**Planning Permit No. P164/17**  
**140 High Street, Mansfield VIC 3722**  
**Section 72 Amendment**

Following the pre-application meeting held with Melissa Crane and yourself on 29 October 2025, we confirm our client seeks approval from Council under section 72 of the Planning and Environment Act 1987 (the Act) to make changes to the approved service station. Generally, the amendments seek the introduction of a shop and (ancillary) laser car wash facility to the rear of the subject site to enhance the service offering to the community in a site responsive manner that enhances the commercial capacity of the approved service station.

Figure 2: Proposed revised site plan

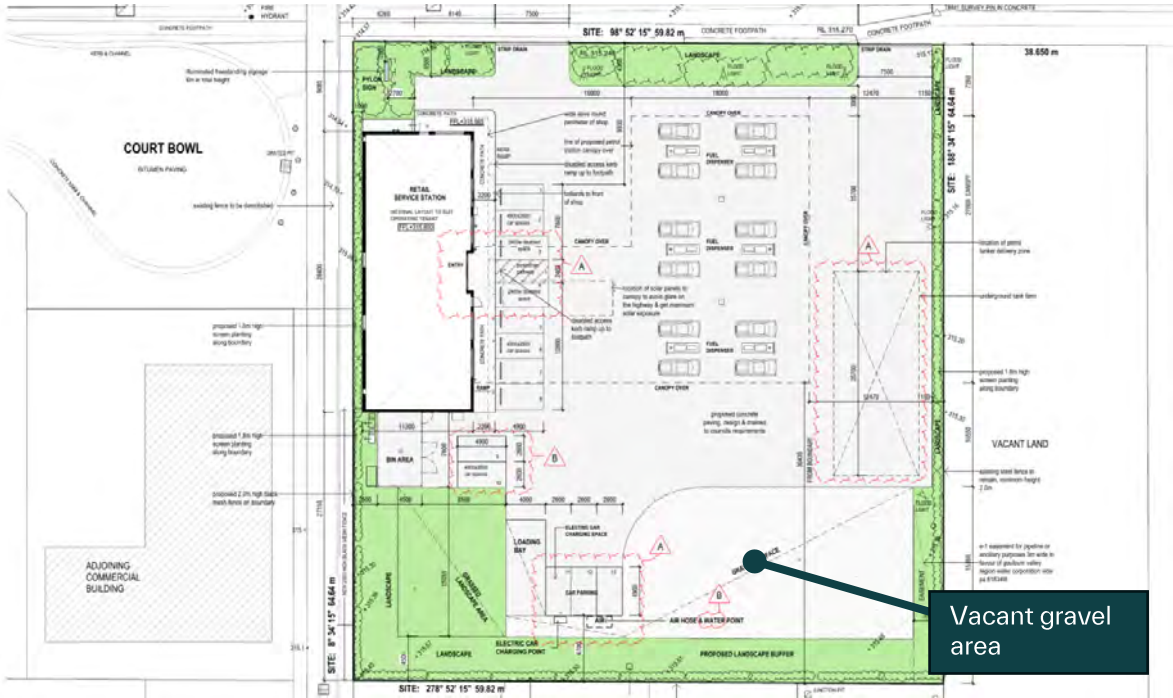
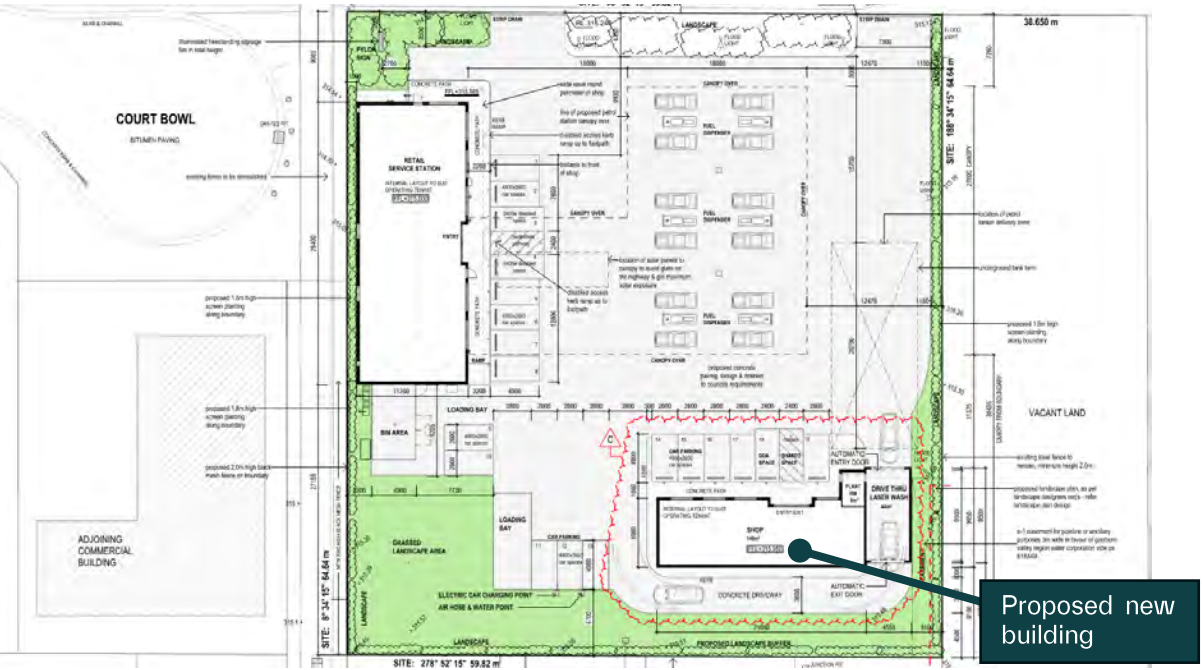
As highlighted (using clouds) on the accompanying plans prepared by DCA Design (extracted in the **comparison overleaf**), the key changes include:

- The addition of a new building at the rear within the southeastern corner of the site (currently a vacant, gravel area per the endorsed plans) as part of the currently approved service station, comprising an integrated shop and car wash.

- The new shop (marked as 'retail 2') space has an area of 140 sqm. The shop will be managed in conjunction with service station operator however may function separately and independently in relation to the sale of goods and services from the services station shop (marked as 'retail 1'). The shop (retail 2) will to a large degree service customers already attending the site, and complement the offering to the community by stocking local produce, food and beverage and thus celebrating and supporting the local community and economy with particular focus on the 'cottage industry'.

- The new laser car wash area has an area of 44sqm is attached to the east of the shop (retail 2), with associated driveway traversing to the rear of the new building. The min. 4.5m wide landscape buffer on the south boundary is unchanged. The car wash facility will function as an ancillary component to the service station.

- There will be six additional car parking spaces to the frontage (north) of the shop (retail 2), including one DDA space. The amendment will increase the total parking provision on-site from 13 to 19 spaces (including three accessible parking spaces).

- Relocate loading bay slightly at the rear.

**Figure 3: Extract of streetscape elevation**

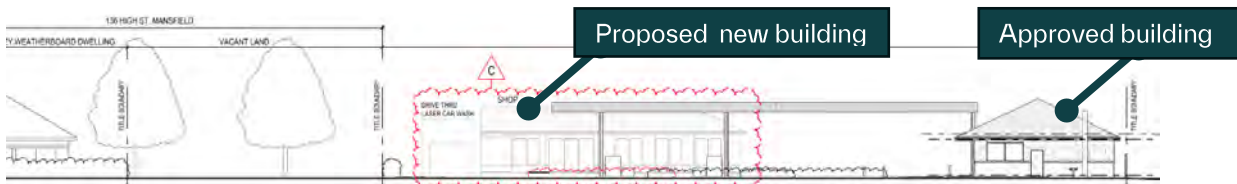
- The placement of the building at the rear (southeast) corner of the lot ensures minimal visual impact in the streetscape context.

- the maximum building height of the new building including 5.7m to the ridgeline of the shop (retail 2) and 4.55m to the laser car wash, and therefore is compliant and not increased from the canopy height under the permit;
- the design and external finishes of the new building features selected river stone wall cladding and muted / earthy tones to other materials that will suit the desired character and be consistent with the existing approval; and
- the presentation to the streetscape of High Street (as part of the Mansfield Township Approach) is largely unchanged and would retain the same level of landscaping as approved, including maintenance of a landscaped frontage and around the perimeter boundaries adjacent to residential land to the south.
